RE: SSD-10464 50-52 Phillip Street New Hotel/Residential Building Stage 1 Concept DA

We are writing to object to the Stage 1 Concept State Significant Development Application (SSDA) for the site at 50-52 Phillip Street Sydney (the site), which was exhibited between 15th April 2021 and 12th May 2021. We are acting on behalf of The Owners Strata Plan 31979, the adjoining property at 56-70 Phillip Street (see **Figure 1**).

Figure 1 - Cadastre (Source: Mecone Mosaic)

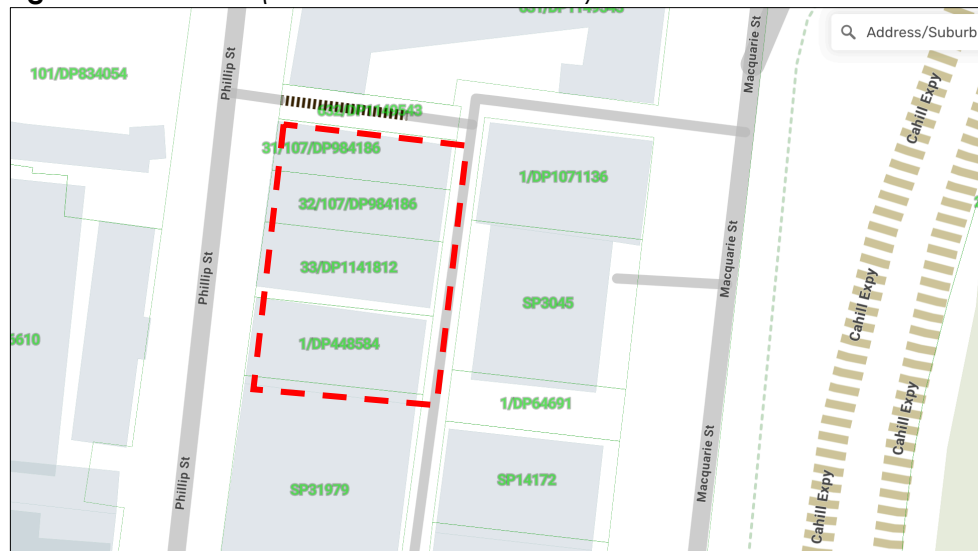
The location of these allotments is indicated at **Figure 1**. Notably, the description of the site does not include Lot 632/DP1149543, which is the covered lane to the immediate north of these allotments. The registered proprietor of Lot 632 is Government Property NSW. Lot 632 does not appear to be limited in stratum (as indicated in the EIS at page 28).

There does not appear to be any reference in the EIS to owner's consent having been obtained from Government Property NSW. As such, the proponent will need to obtain owner's consent from Government Property NSW before any DA can be determined (see clause 49(1)(b) of the *Environmental Planning and Assessment Regulation 2000 (EPA Regulation)*), unless the Planning Secretary has notified the proponent in writing that the development constitutes "public notification development", and notification has been given in accordance with clause 49(2) of the EPA Regulation.

Figure 3 – Testing of Interface of Domain and Botanic Gardens SAPs

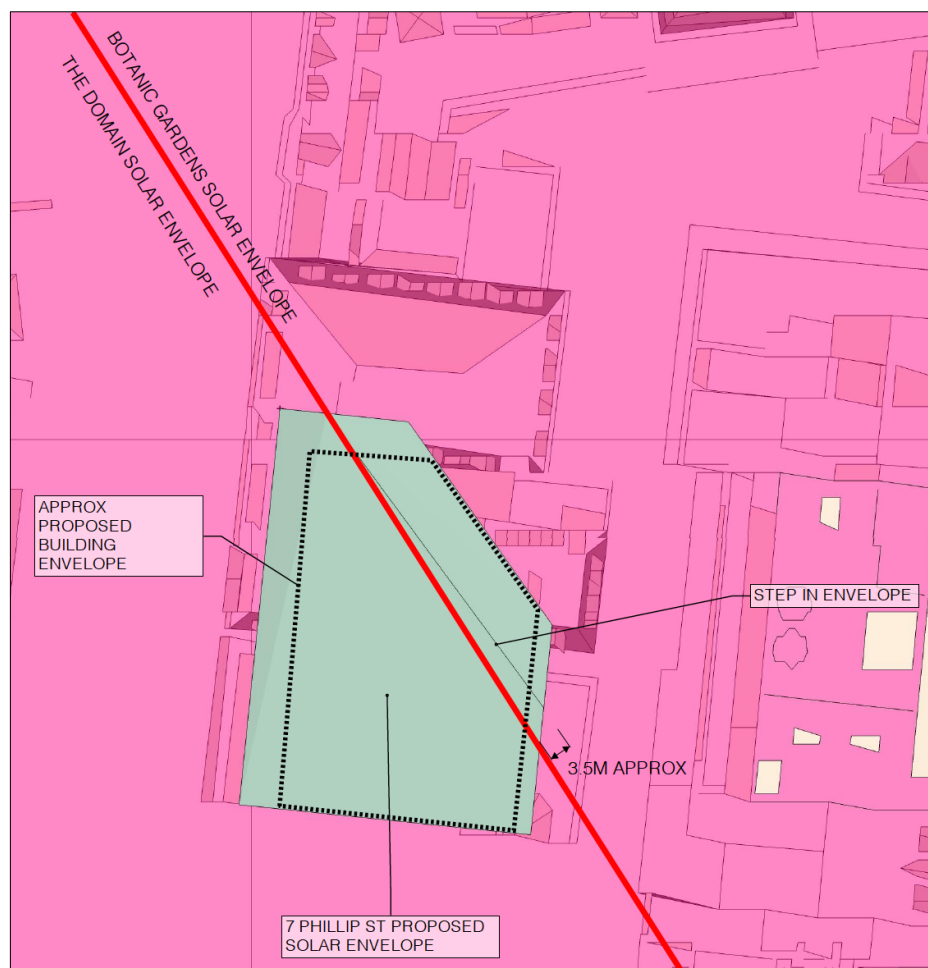
Firstly, the step in the upper level of the building does not align properly with the junction of the two SAPs, resulting in an encroachment that increases from nil in the northwest to 3.5 metres in the southeast, as shown in **Figure 3**.

Figure 4 – Testing of the Domain SAP

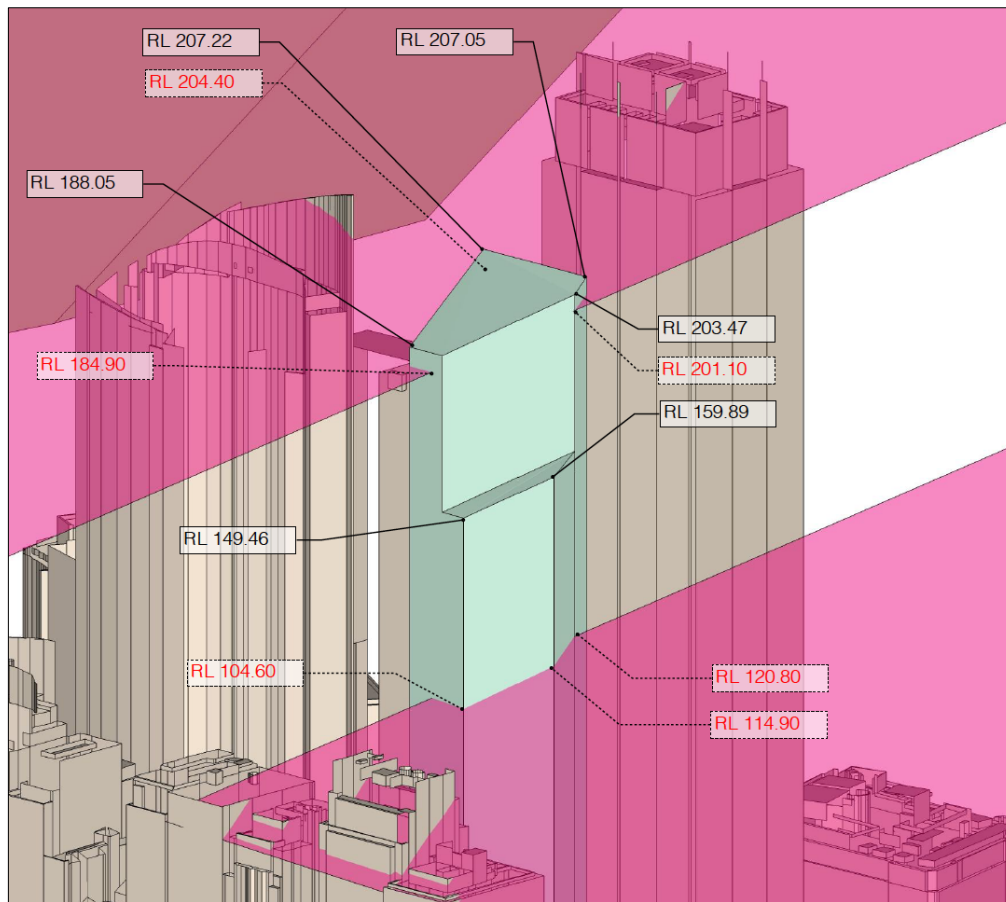
Secondly, the top of the proposed building envelope extends above the Domain SAP, as shown in **Figure 4**.

Figure 7 - Extract of FJMT Design Report (p55)

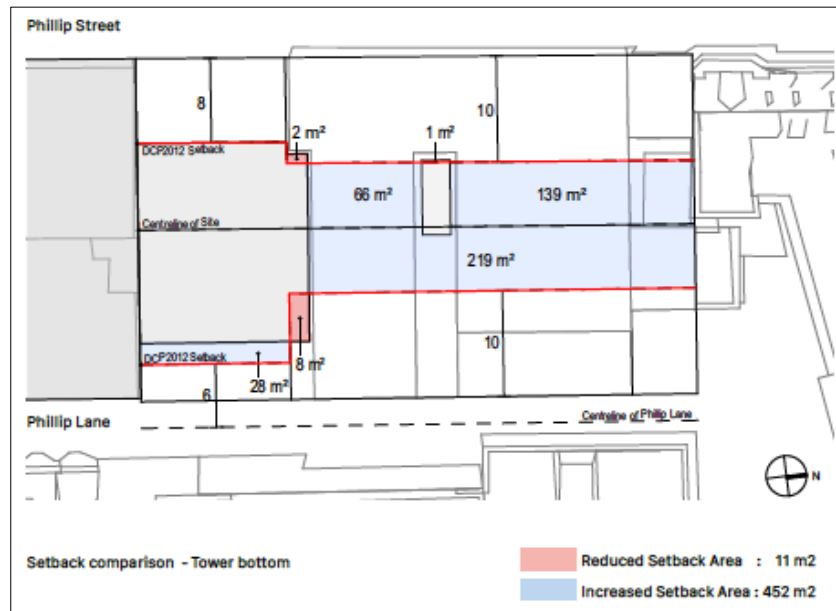
The applicant's own analysis above illustrates the following adverse implications of the proposal upon the future development potential of No. 70 Phillip Street:

- At only 650sqm, the maximum floor plate achievable on 70 Phillip will be too small for efficient commercial office, or other non-residential development.
- A wall of towers with minimal separation will be presented to the eastern edge of the CBD.
- Gaps between buildings are inadequate for solar penetration or view sharing.
- Likely wind concentration impacts of such tall, narrow building separations.

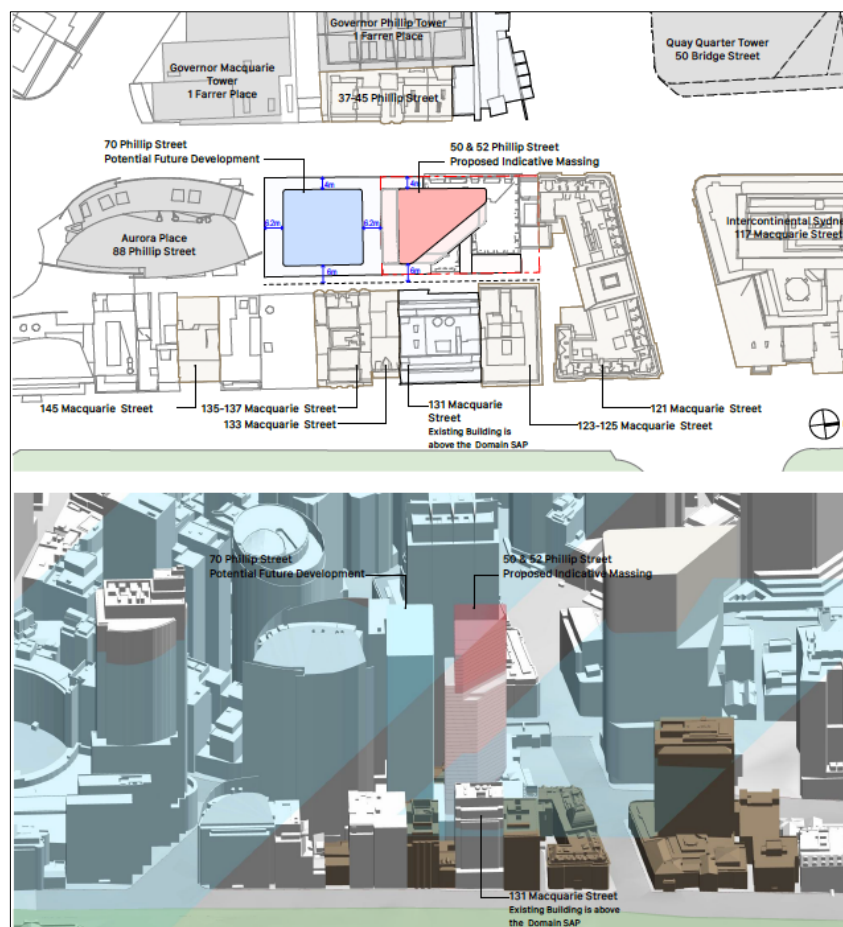
Furthermore, the site and floor plate dimensions and the height of buildings proposed are not appropriate for nil setback arrangements. The resultant tower wall form would be inconsistent with the underlying massing principles of the Central Sydney planning framework.

Figure 9 – Encroachment into Governor's Domain and Civic Precinct (Source: FJMT annotated)

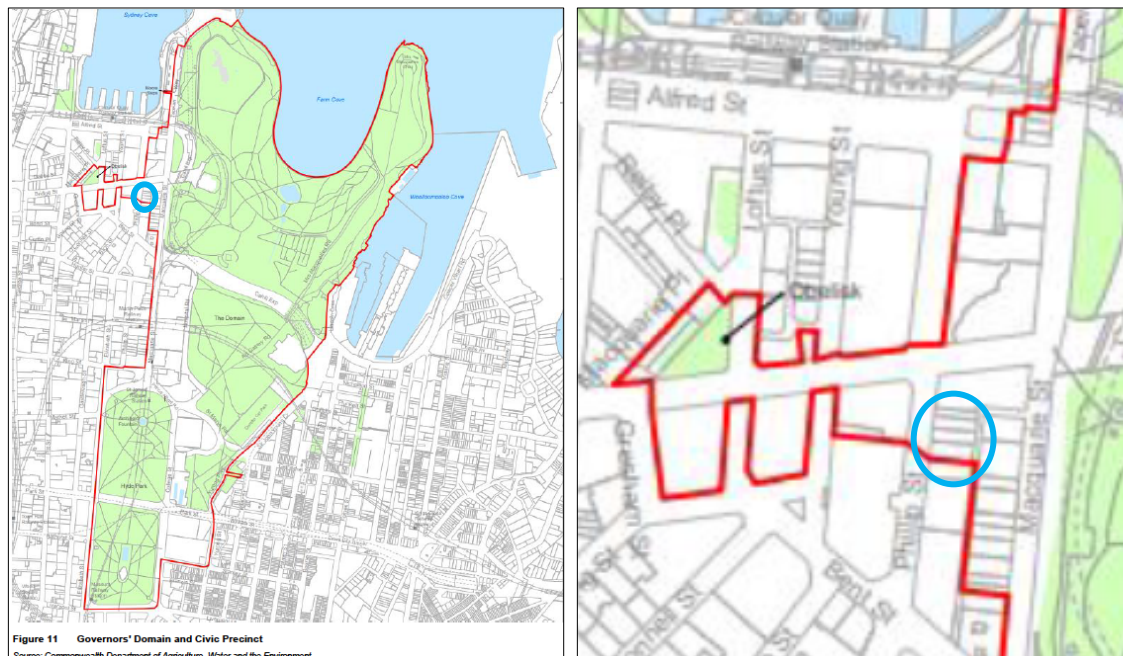
On 9 February 2021, the Governors' Domain and Civic Precinct was included in the National Heritage List under the *Environment Protection and Biodiversity Conservation Act 1999* (EPBC Act). As can be seen in **Figures 8 to 10** the proposed development essentially involves a building footprint located just outside the listed Precinct, but with the majority of the building footprint cantilevering into the precinct. The Chief Secretary's Building is indicatively circled in blue in both maps of the Governors' Domain and Civic Precinct.
